**PLEASANT PRAIRIE PLAN COMMISSION MEETING
VILLAGE HALL AUDITORIUM
9915 39th AVENUE
PLEASANT PRAIRIE, WISCONSIN
6:00 P.M.
July 23, 2018
AGENDA**

**PLEASANT PRAIRIE SPECIAL PLAN COMMISSION MEETING
VILLAGE HALL AUDITORIUM
9915 39TH AVENUE
PLEASANT PRAIRIE, WISCONSIN
5:30 P.M.
July 2, 2018**

**PLEASANT PRAIRIE PLAN COMMISSION MEETING
VILLAGE HALL AUDITORIUM
9915 39TH AVENUE
PLEASANT PRAIRIE, WISCONSIN
6:00 P.M.
July 9, 2018**

DEDICATED TREE PRESERVATION
AND PROTECTION, ACCESS AND
MAINTENANCE EASEMENT DETAIL

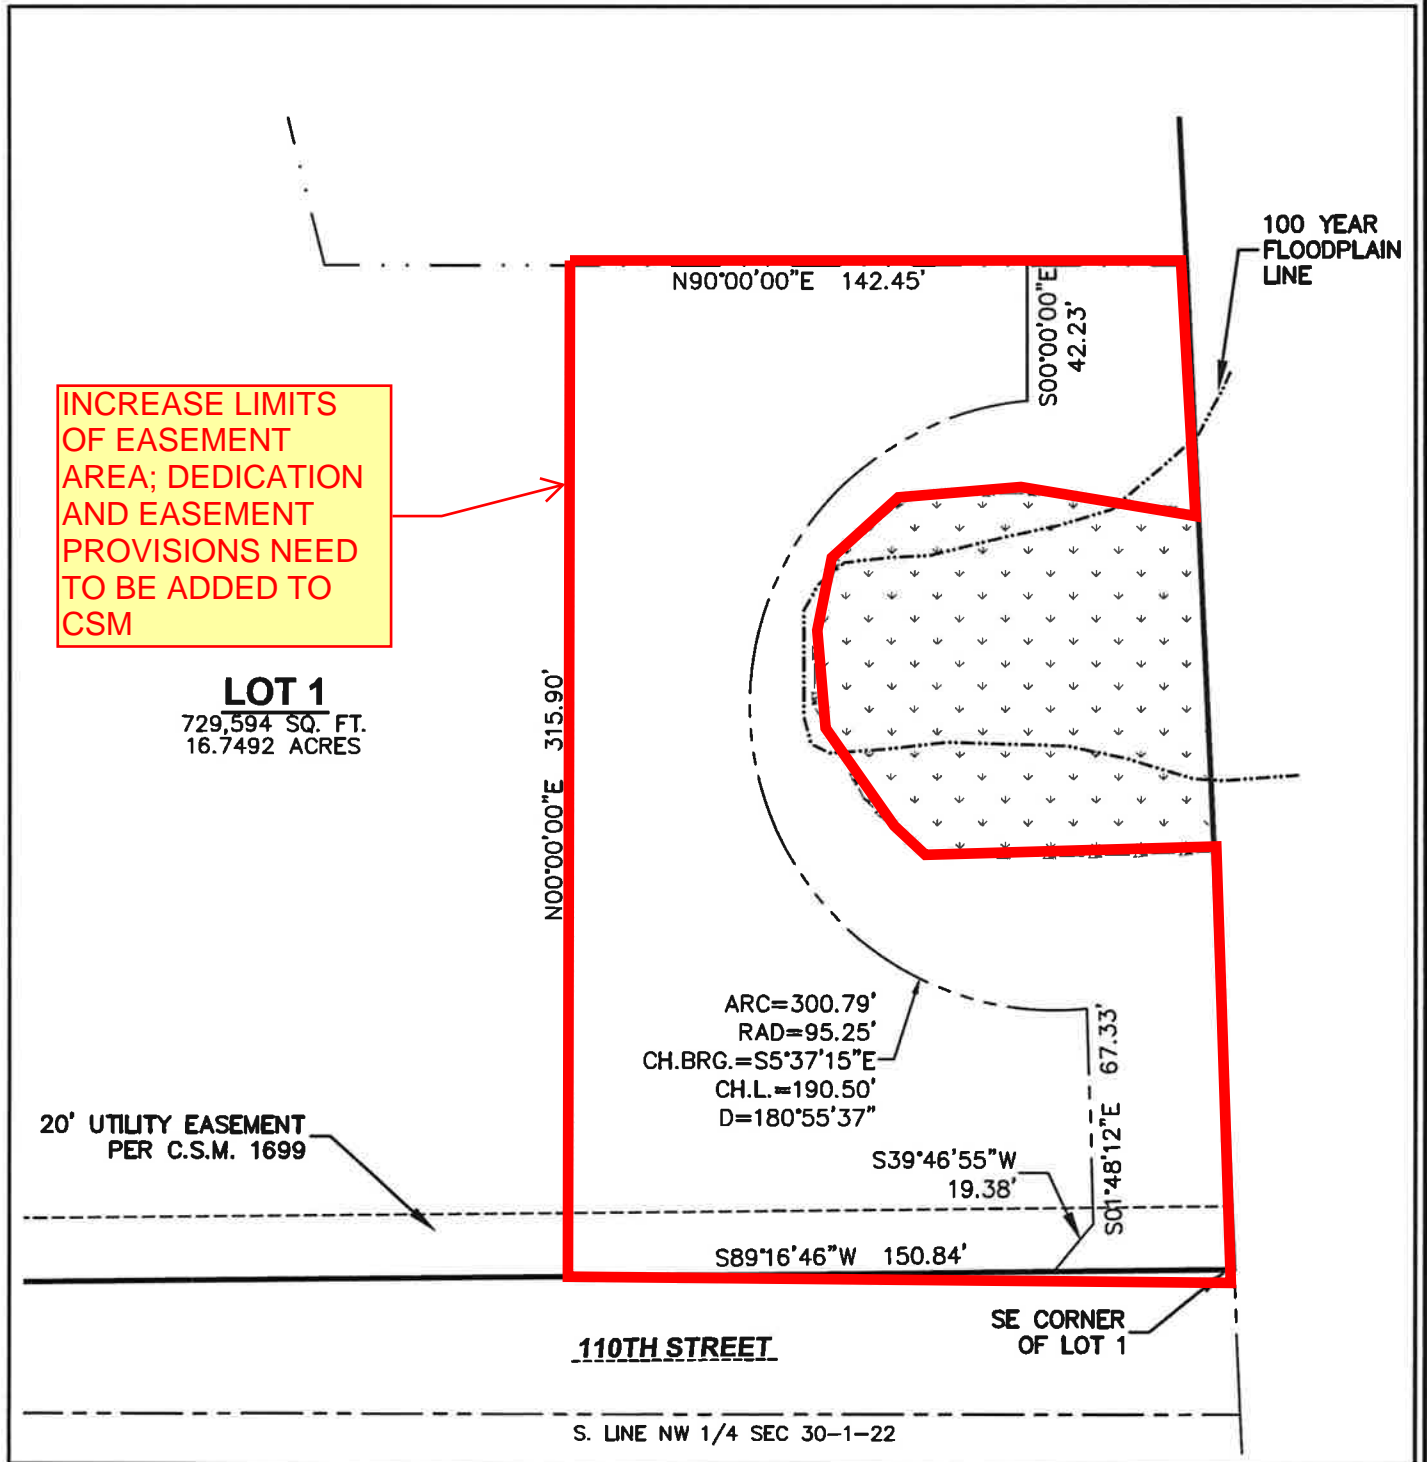
EASEMENT
DEDICATION AND
PROVISIONS NEED
TO BE ADDED TO
CSM

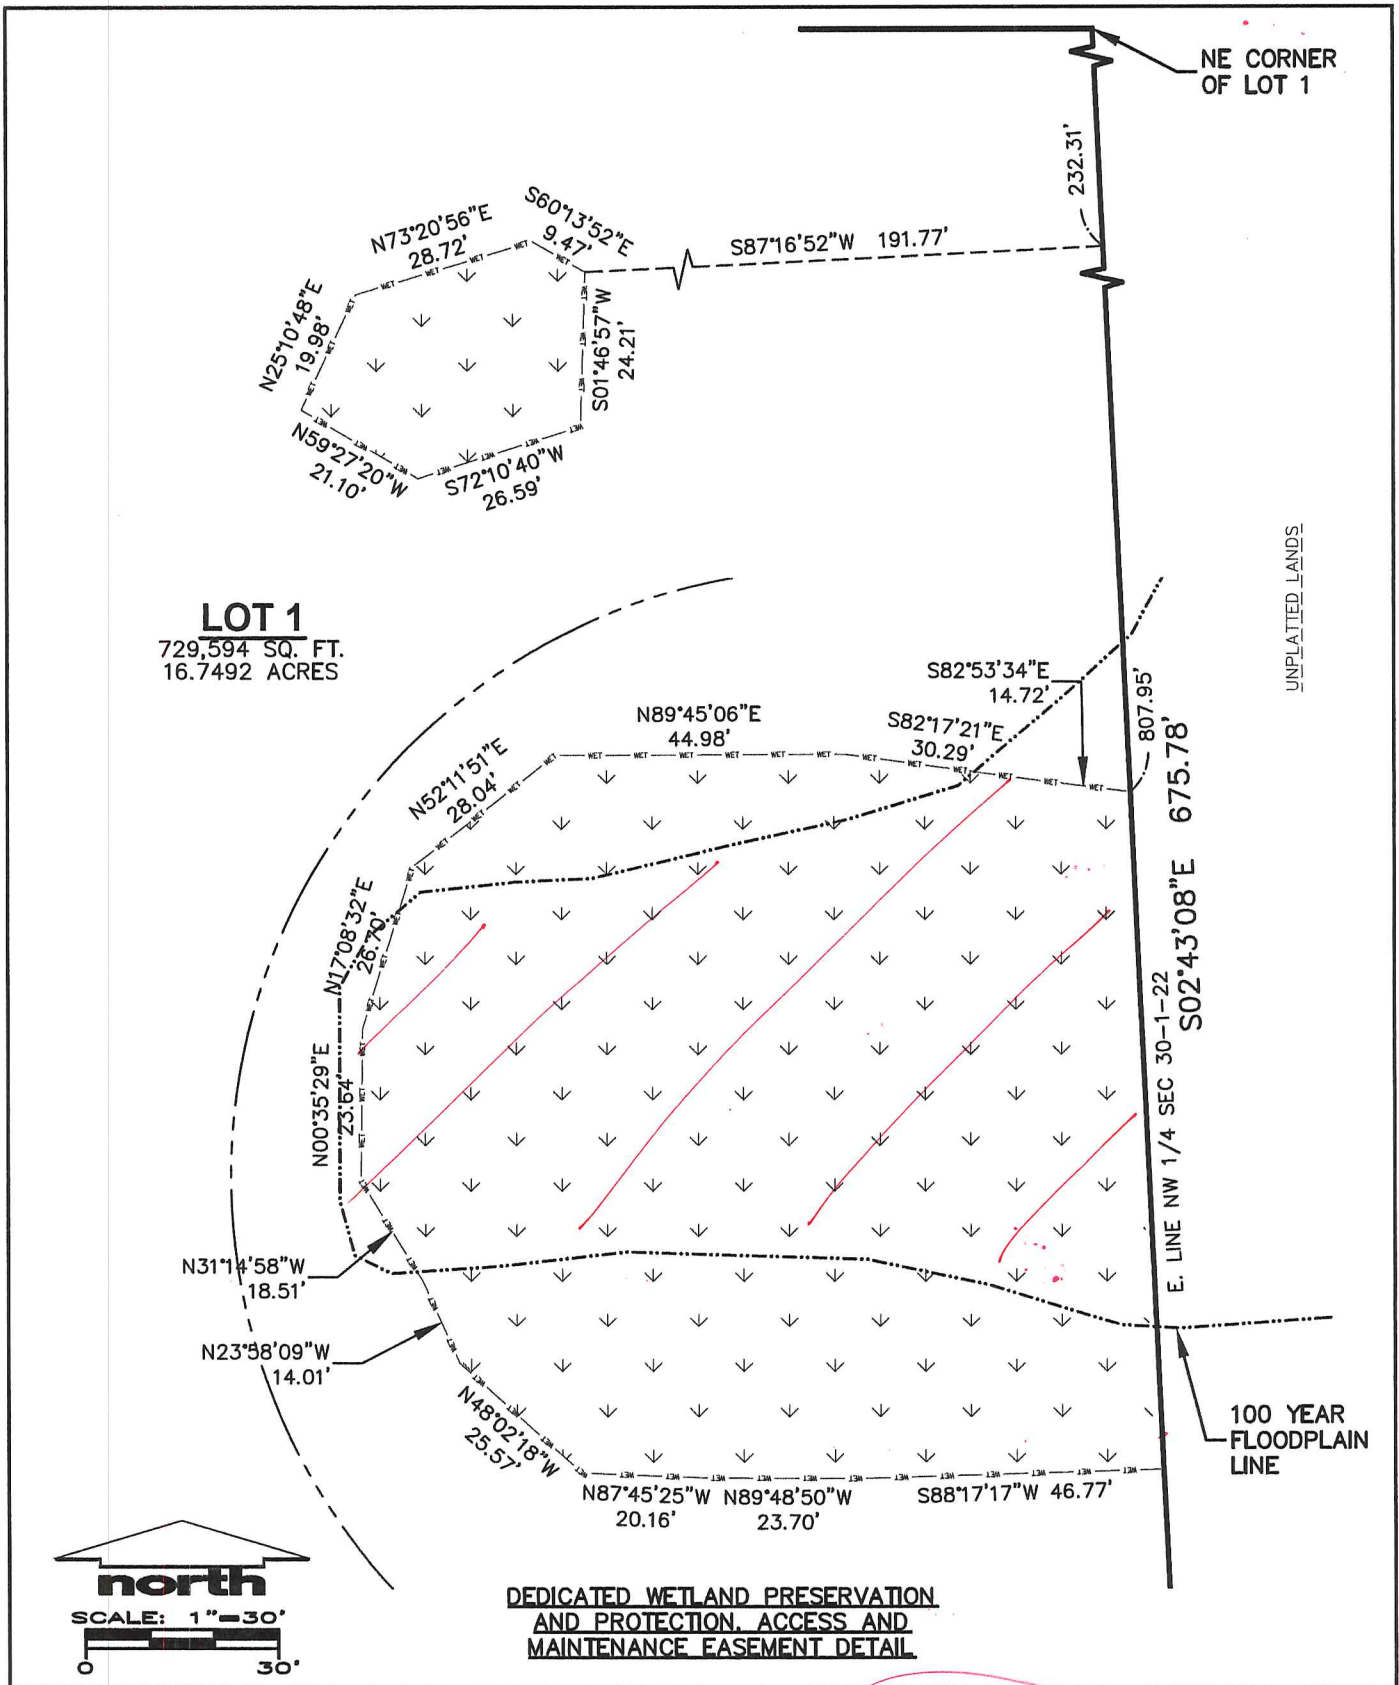
show a
Dedicated
Access Easement
to storm water
Retention Basin
see sheet - of -
SHEET 1 OF 10

DEDICATED STORMWATER DRAINAGE,
RETENTION BASIN, ACCESS AND
MAINTENANCE EASEMENT DETAIL

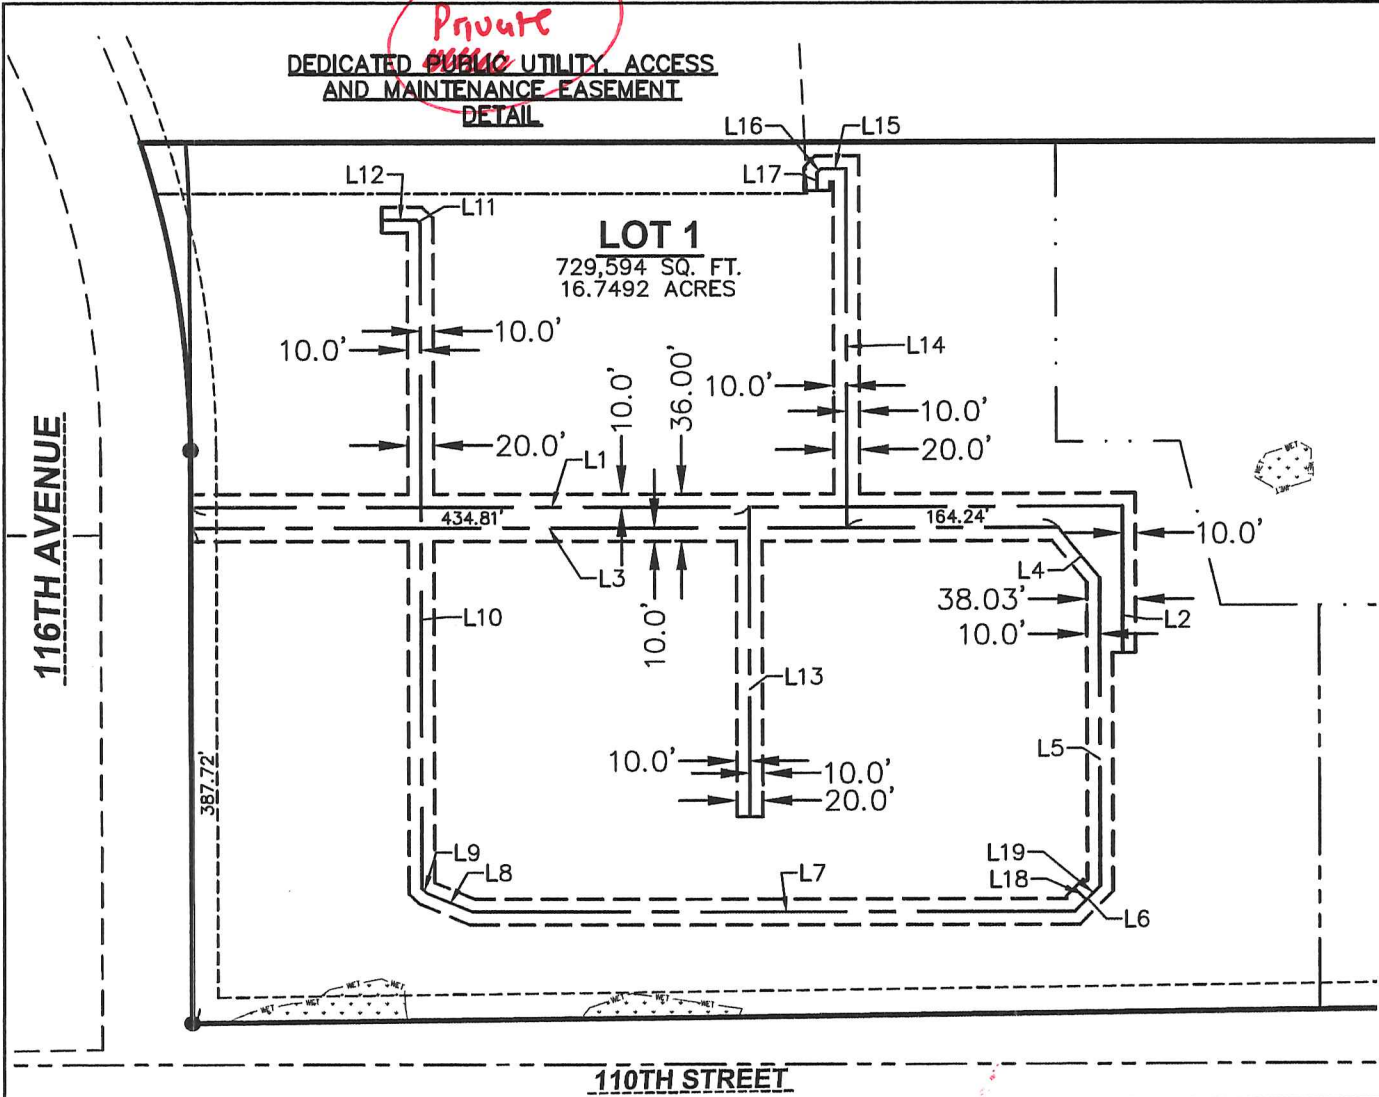
Clearly show a
symbol in legend
for easement area

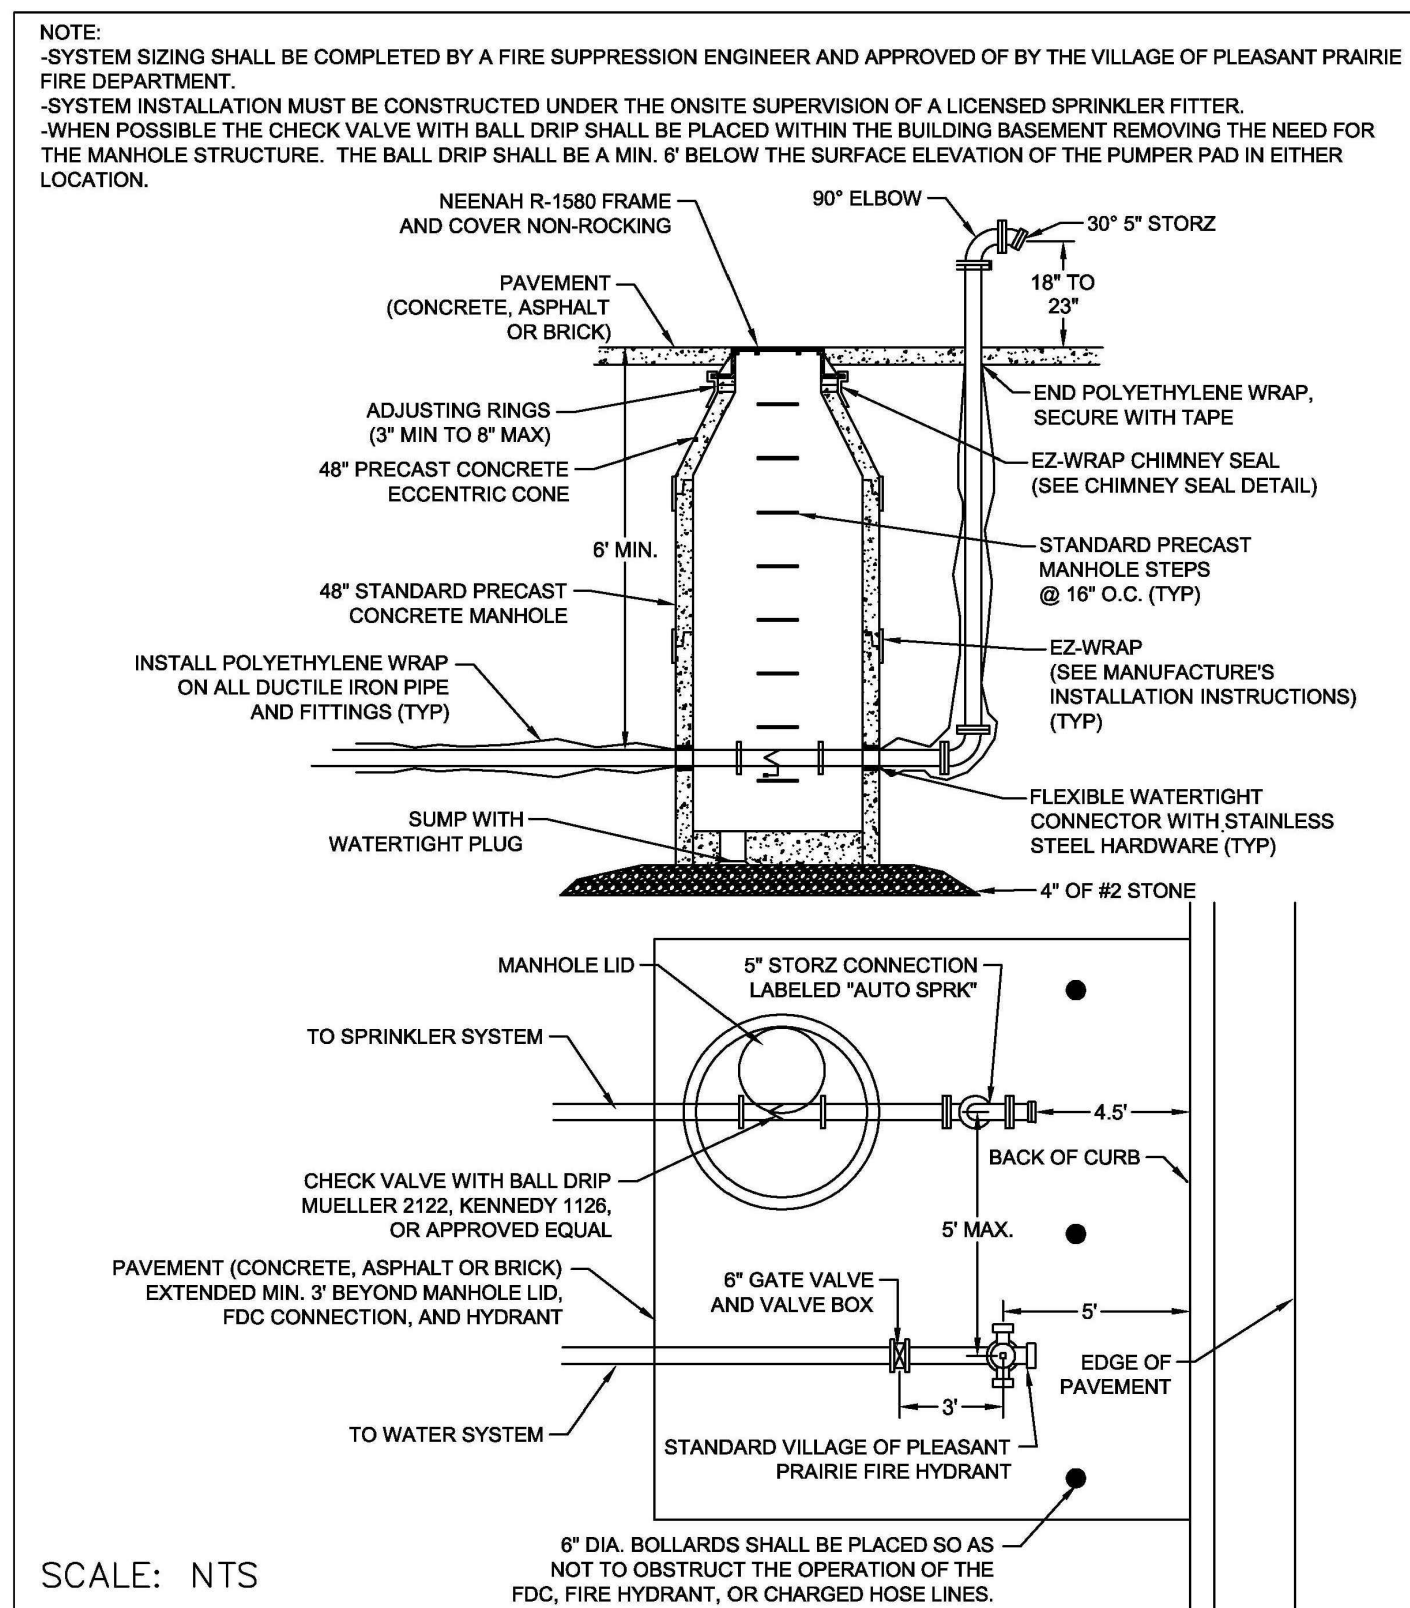
WATER MASTER METER
FACILITY NEEDS TO BE
REVIEWED AND
APPROVED BY THE
PUBLIC WORKS
DEPARTMENT. MAKE
REQUIRED CHANGES BY
DPW AND ELIMNATE ANY
REFERENCES TO OTHER
MUNICIPALITIES
